IEEE P802.15
Wireless Personal Area Networks

Project	IEEE P802.15 Working Group for Wireless Personal Area Networks (WPANs)	
Title	MSCs Incorporating New FC SL/DME/MLME Functional Division and Imm-ACK Removal	
Date Submitted	[24 May, 2004]	
Source	[John Sarallo] [Apparent Technologies] [150 Lucius Gordon Drive, West Henrietta, NY 14586]	Voice: [585-727-2014] Fax: [585-214-2461] E-mail: [sarallo@apparent.com]
Re:	[]	
Abstract	[This document contains a list or proposed changes to IEEE Std 802.15.3.]	
Purpose	[The purpose of this document is to propose changes to IEEE Std 802.15.3 to improve compatibility, performance and clarity in the standard.]	
Notice	This document has been prepared to assist the IEEE P802.15. It is offered as a basis for discussion and is not binding on the contributing individual(s) or organization(s). The material in this document is subject to change in form and content after further study. The contributor(s) reserve(s) the right to add, amend or withdraw material contained herein.

This document presents new clause 8 MSCs resulting from Imm-ACKs no longer being used as confirmation commands as presented in 04/202r0 and with the following functional division

Figure 94 - PNC handover MSC

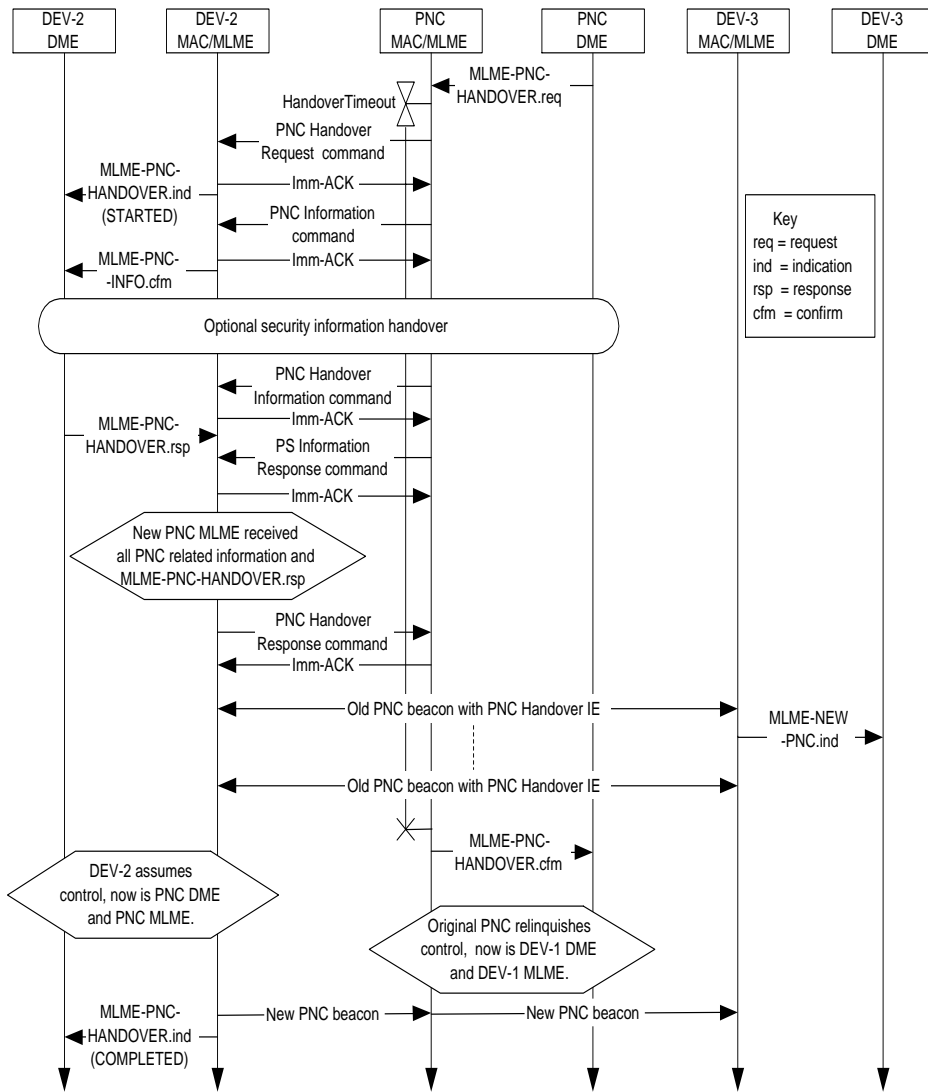
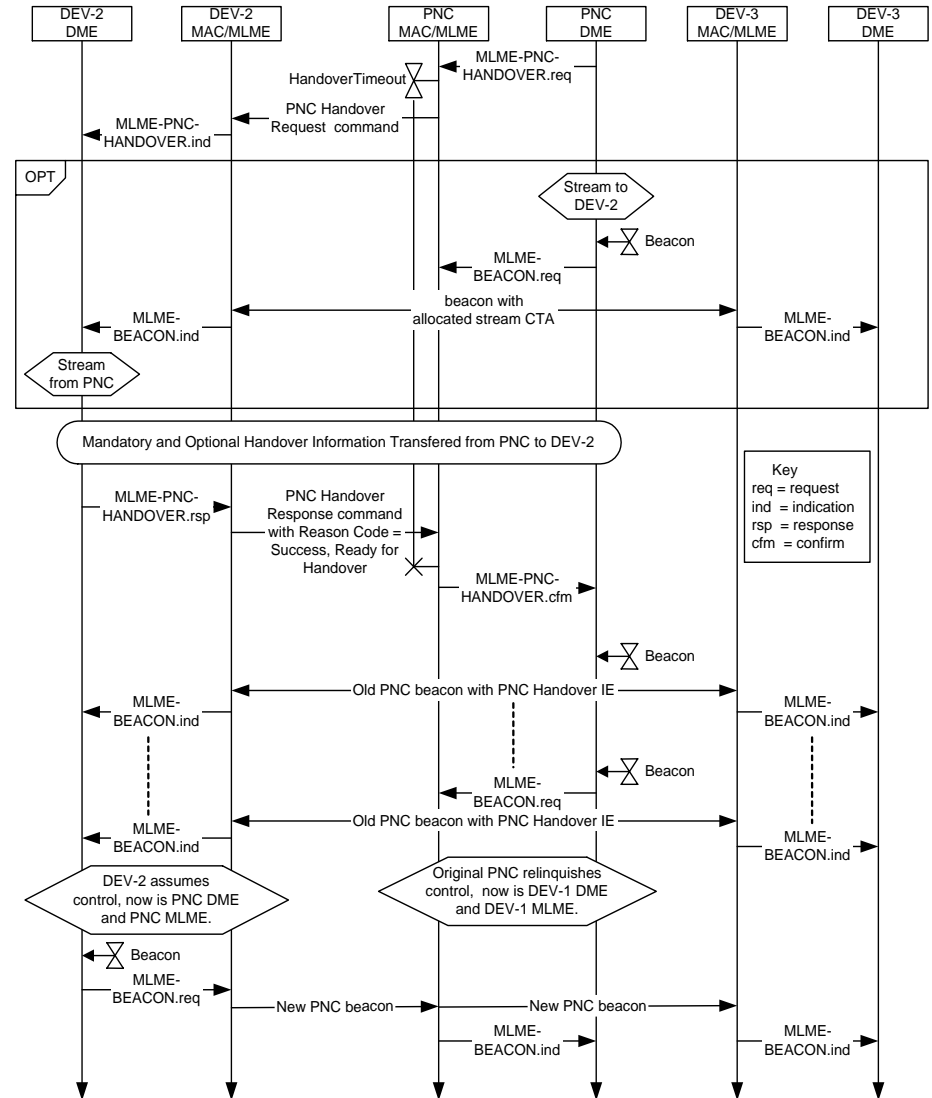
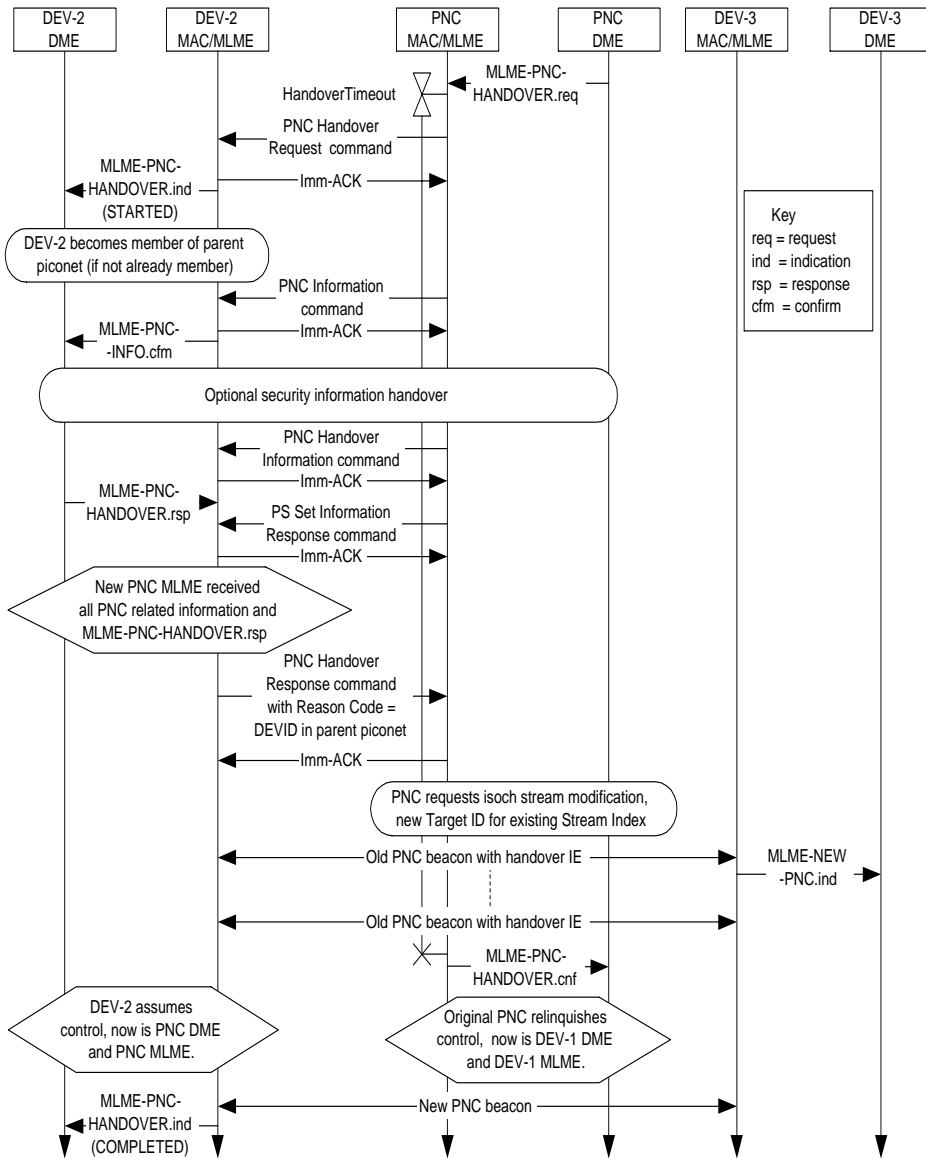
- Shows handover data is optionally transferred in a stream.
